GUILBEAU PARK SUBDIVISION

MASTER DEVELOPMENT PLAN

Re: Guilbeau Park

Please be advised that the Preliminary Overall Area Development Plan (POADP) review for Guilbeau Park (File #83-10-61-24) has been completed. The proposed scheme was jointly reviewed by Traffic Engineering and Planning staff. Analysis of the POADP concludes that the planned proposal is in general compliance with the requirements set forth in Chapter 36 of the City Code.

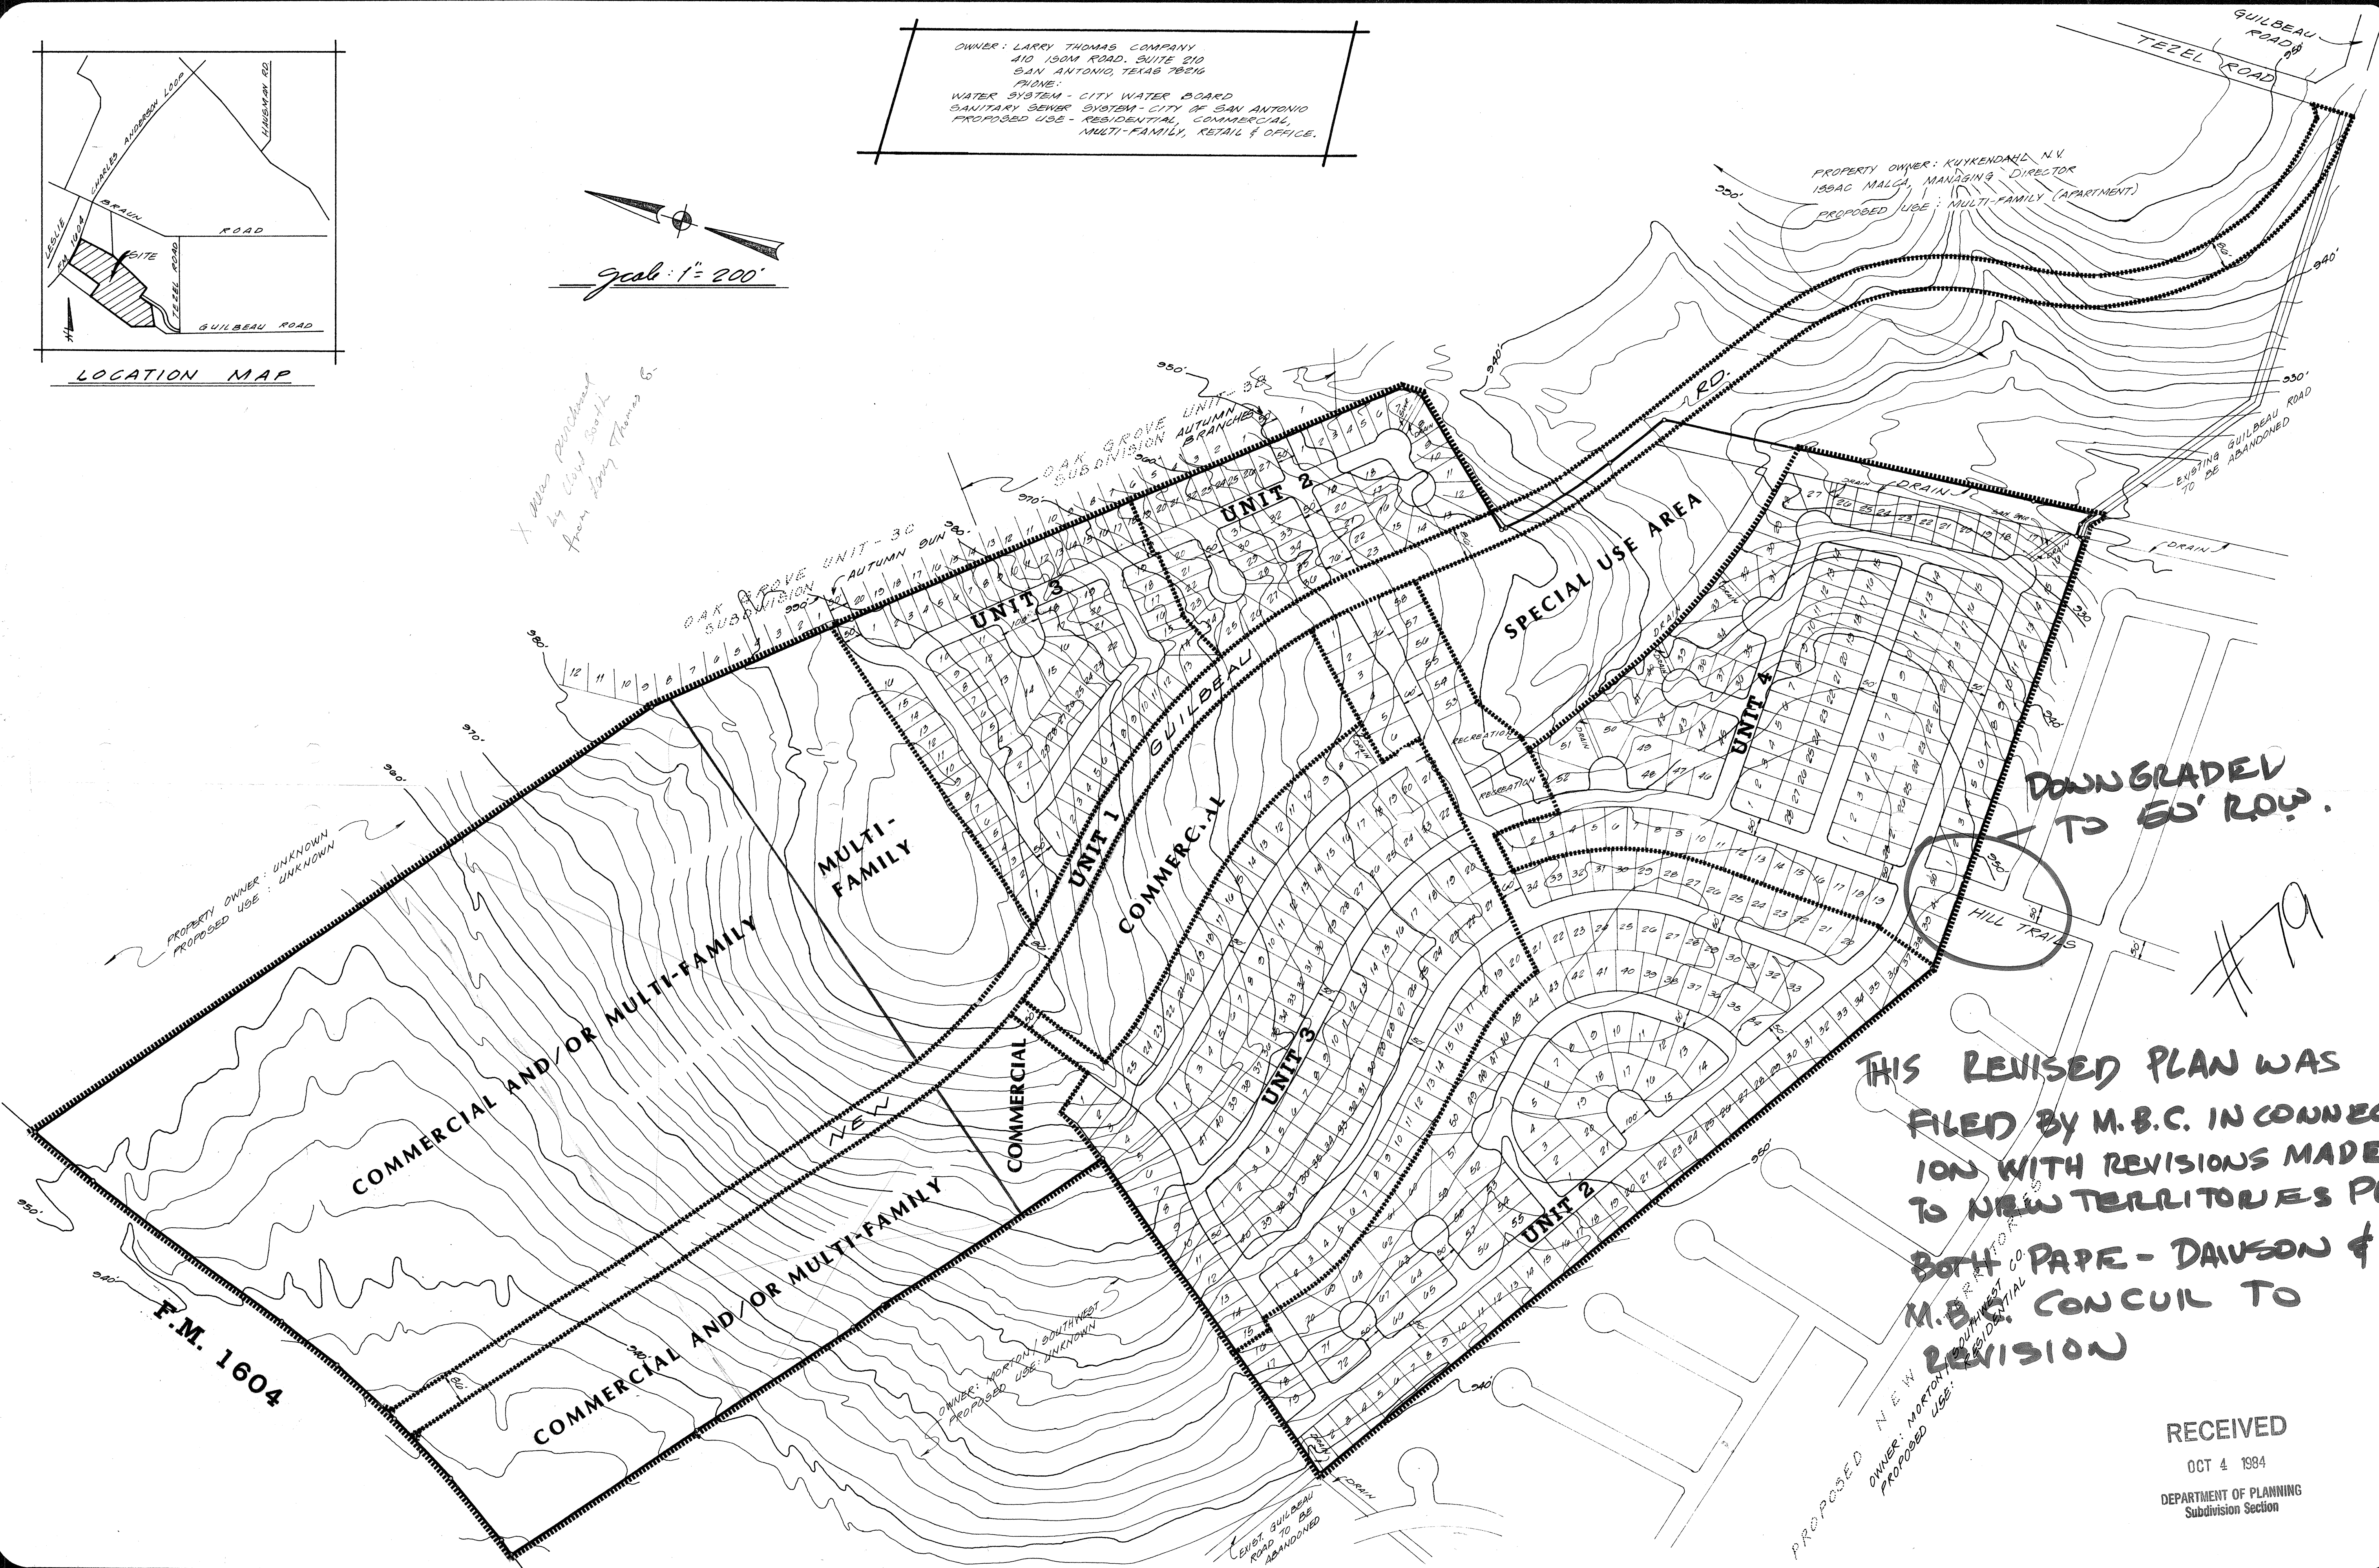
DOWNGRADED TO 60' ROW.

THIS REVISED PLAN WAS
FILED BY M.B.C. IN CONNECTION WITH REVISIONS MADE
TO NEW TERRITORIES PLAN
BOTH PAPER - DAWSON &
M.B.C. CONCUR TO
REVISION

MASTER DEVELOPMENT PLAN

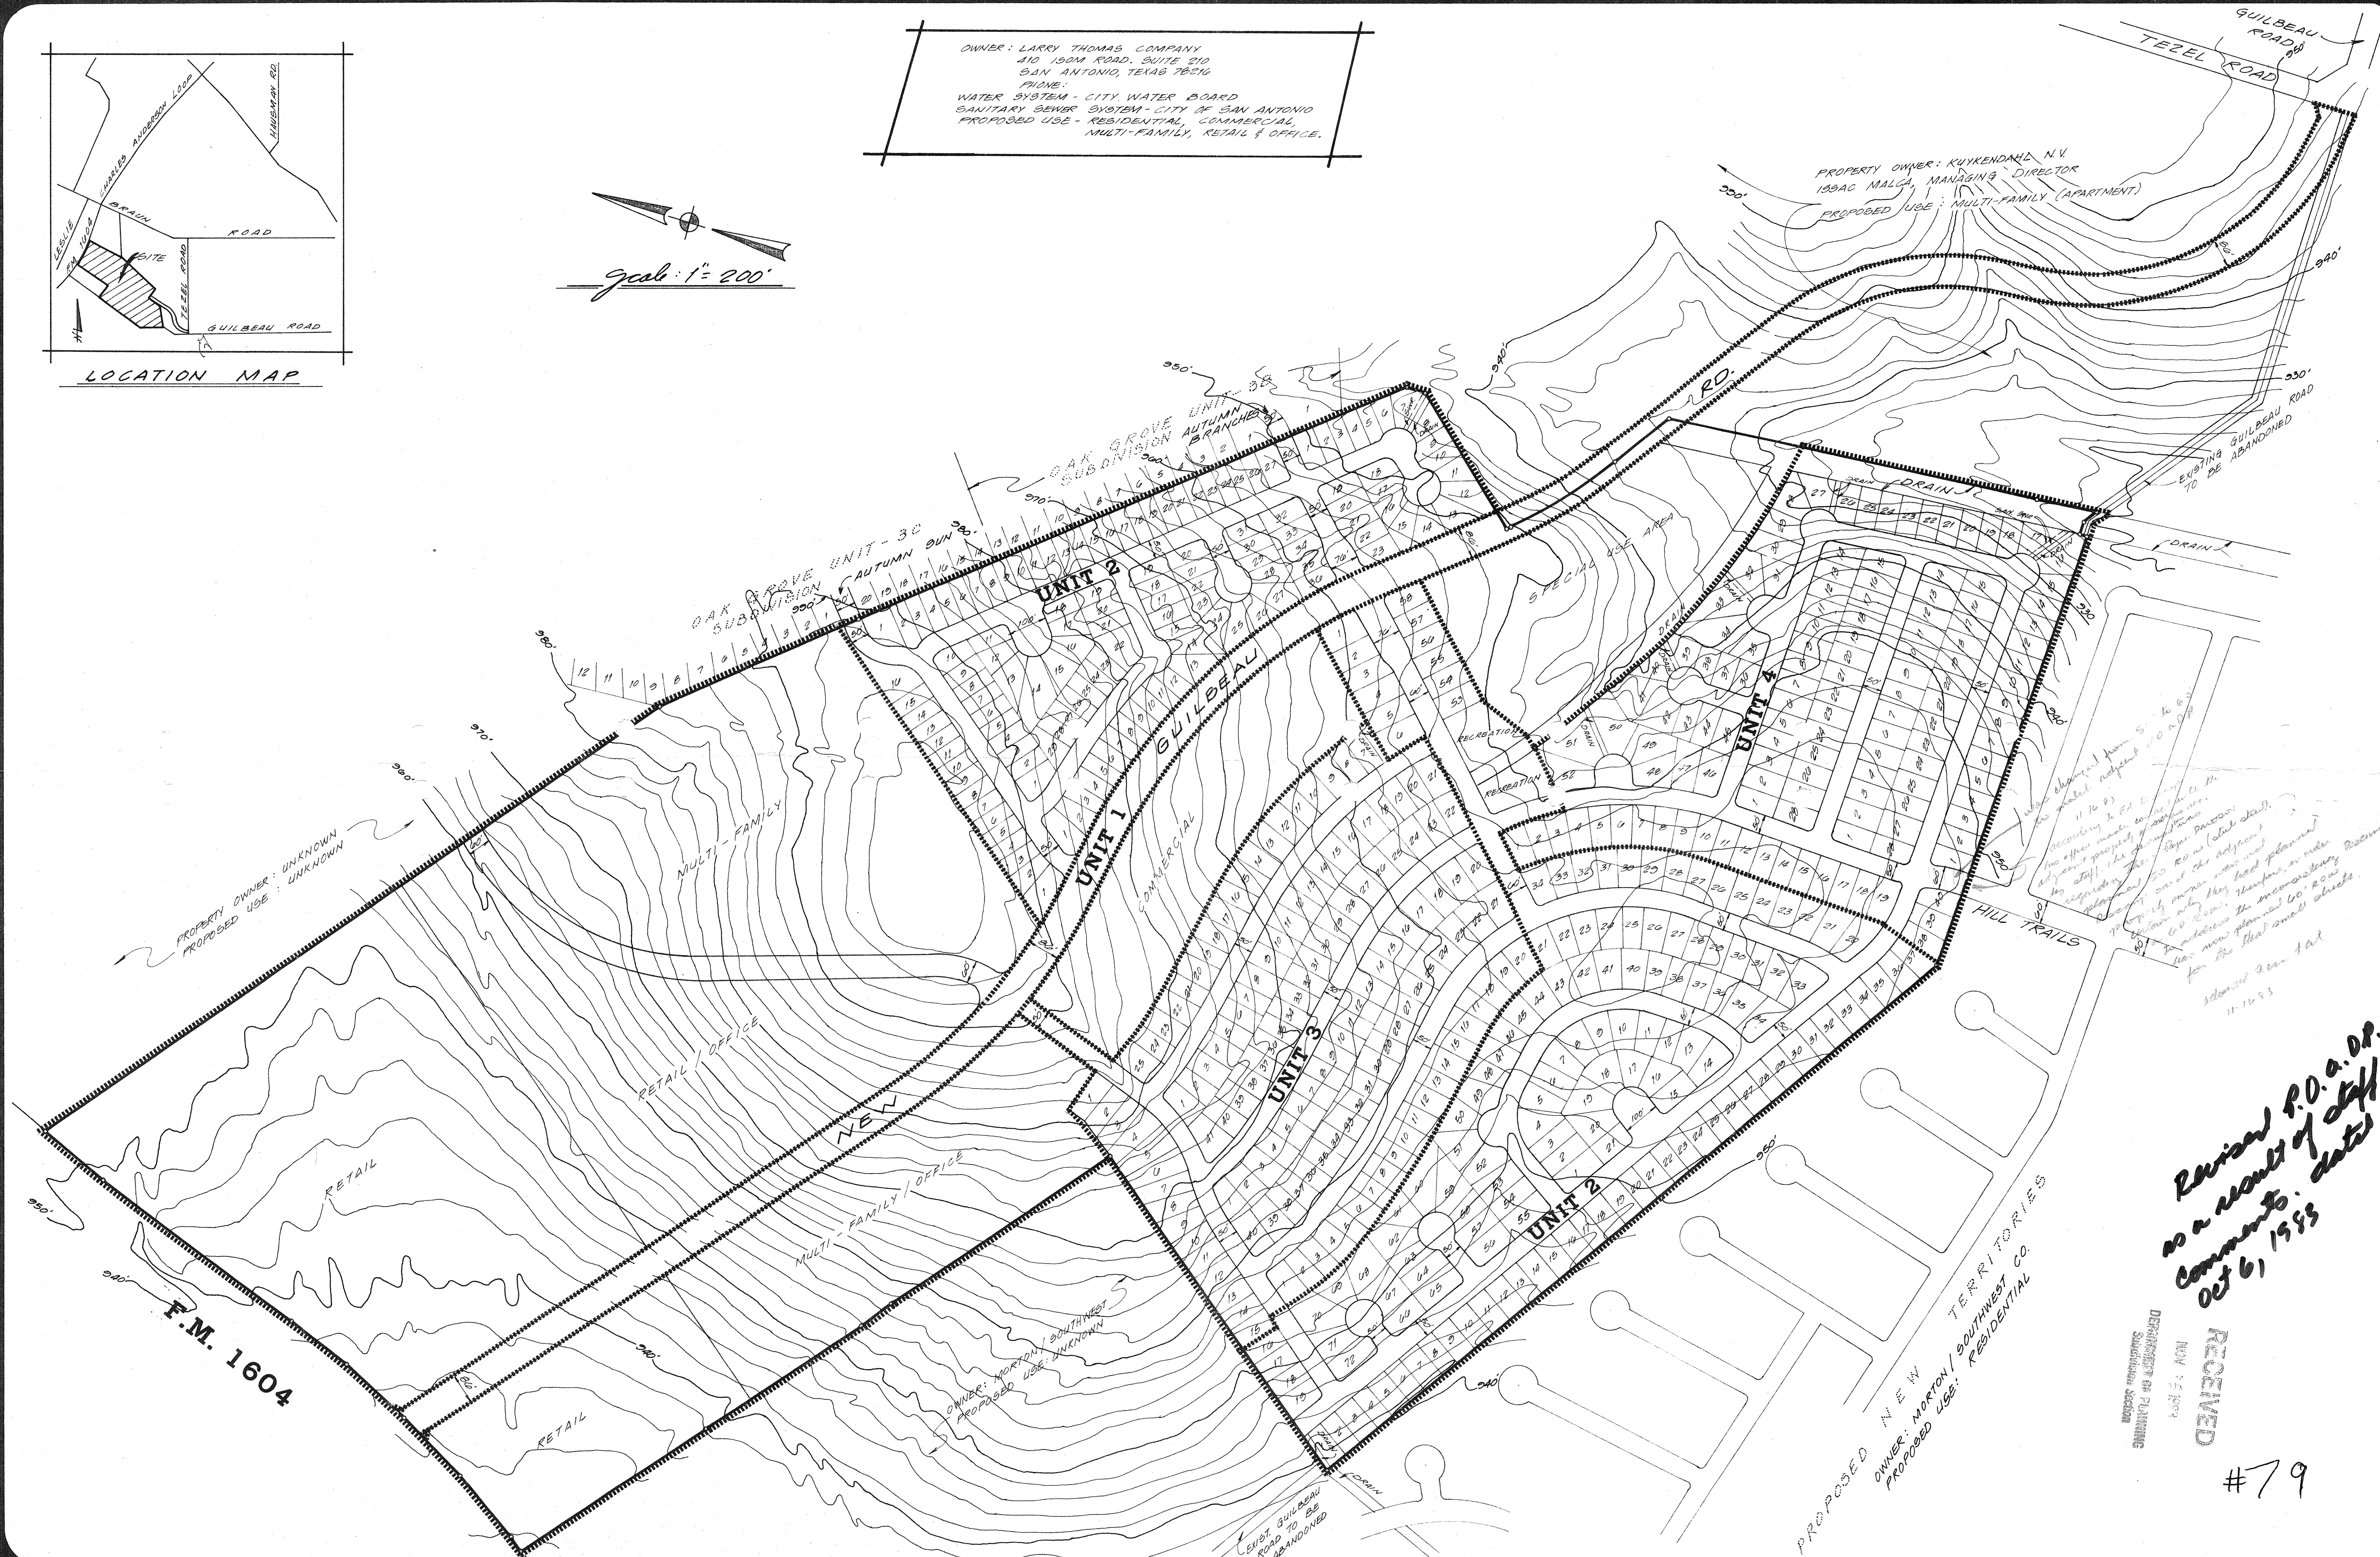
Staff concensus is that the planned Guilbeau Parkway (86' R.O.W.) alignment is in accordance with the current Major Thoroughfare Plan. Additionally, it is noted that the extension of Hill Trails in your subdivision is not consistent with the 60' R.O.W. being provided in that New Territories area. Because of this, it is recommended contact be made with the adjacent property owners in an effort to work out the inconsistency.

COPIES	DATE	NO.	DESCRIPTION
2		1	Revised Master Development Plan to reflect comments of your letter (10/6/83)
1		1	Table 21-7

We feel that a 50 ft R.O.W w/ 30 ft of pavement is sufficient to handle the traffic being generated in that area.
